**DOCUMENT 00 90 00**  
**ADDENDUM**

**ADDENDUM:** 3

**DATE:** JANUARY 26, 2026

**PROJECT:** HOUSING AUTHORITY OF THE CITY OF LA CROSSE  
2025 CAPITAL IMPROVEMENT PROJECTS  
1307 BADGER STREET  
LA CROSSE, WISCONSIN 54601  
PROJECT NO. 25046

**E410**

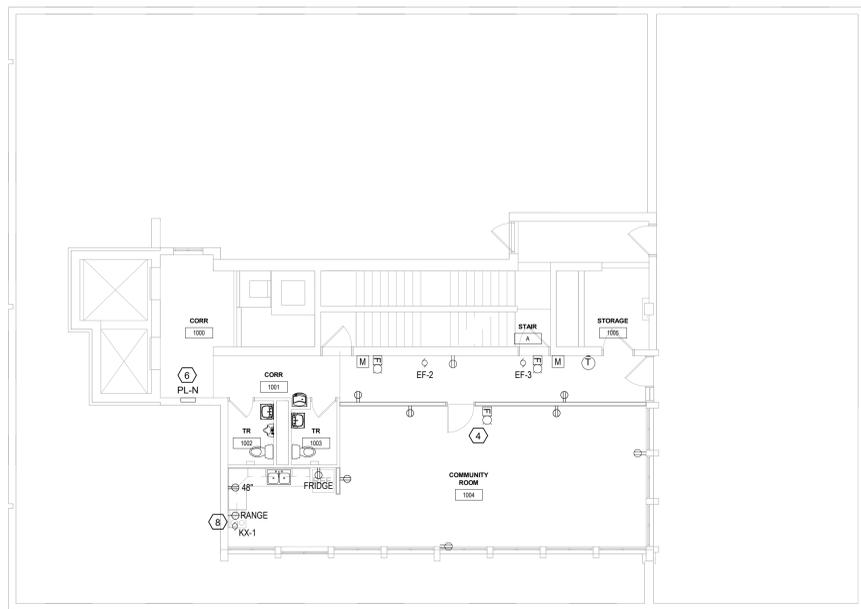
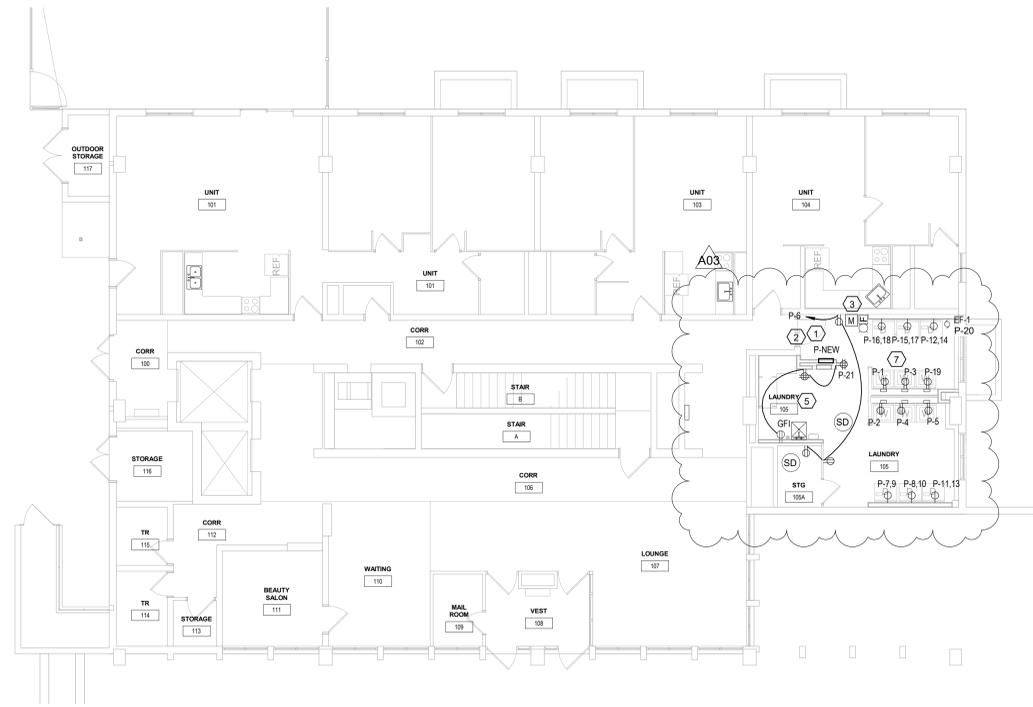
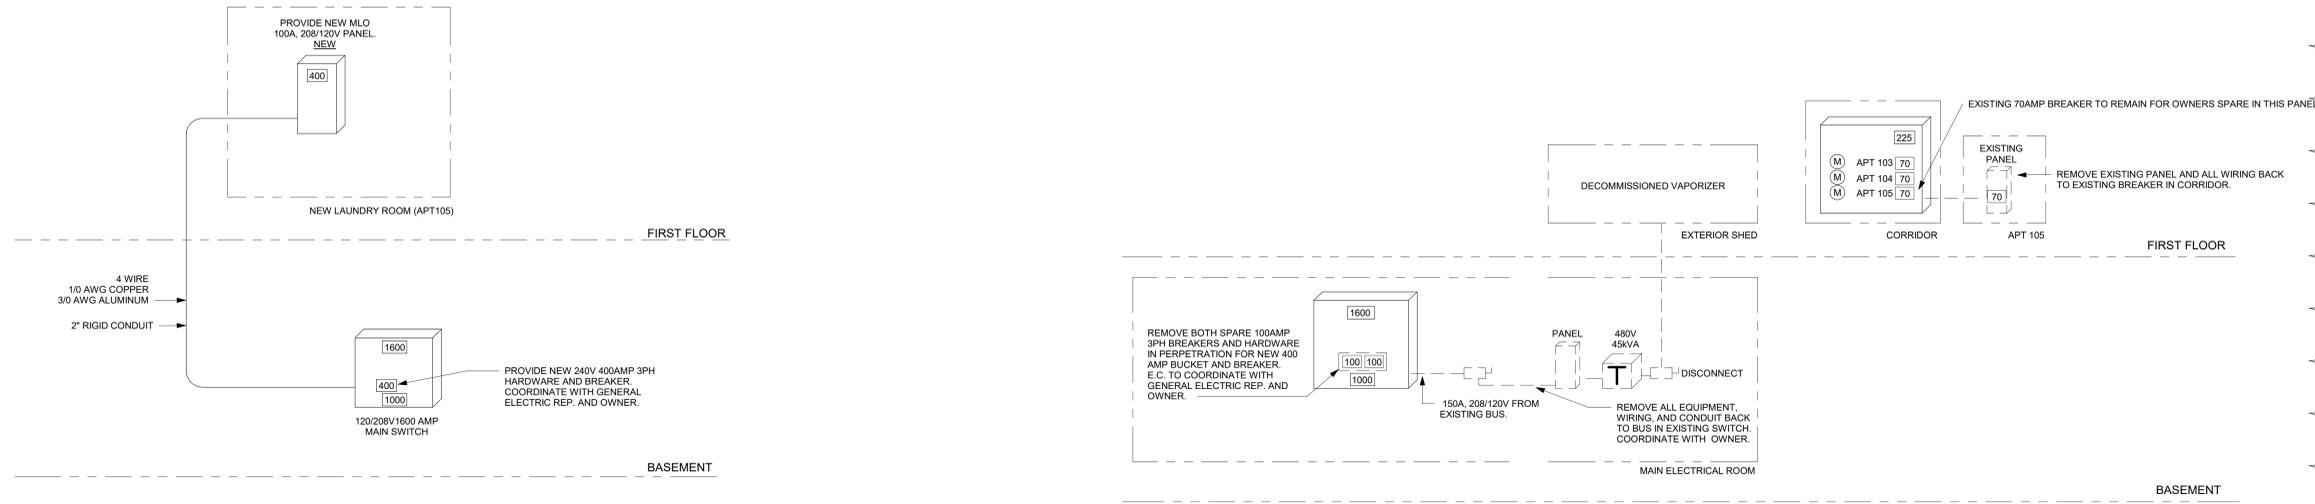
2. Sheet E410 Power Plan 30"x42"
  - a. See the revised sheet included in this addendum. Disregard the previous version.
  - b. Added general receptacles and circuits.
3. Sheet E460 Riser Diagram and Schedules 30"x42"
  - a. See the revised sheet included in this addendum. Disregard the previous version.
  - b. Revised the demolition riser diagram.
  - c. Revised new word riser diagram.
  - d. Revised panel schedule modified. Added notes.
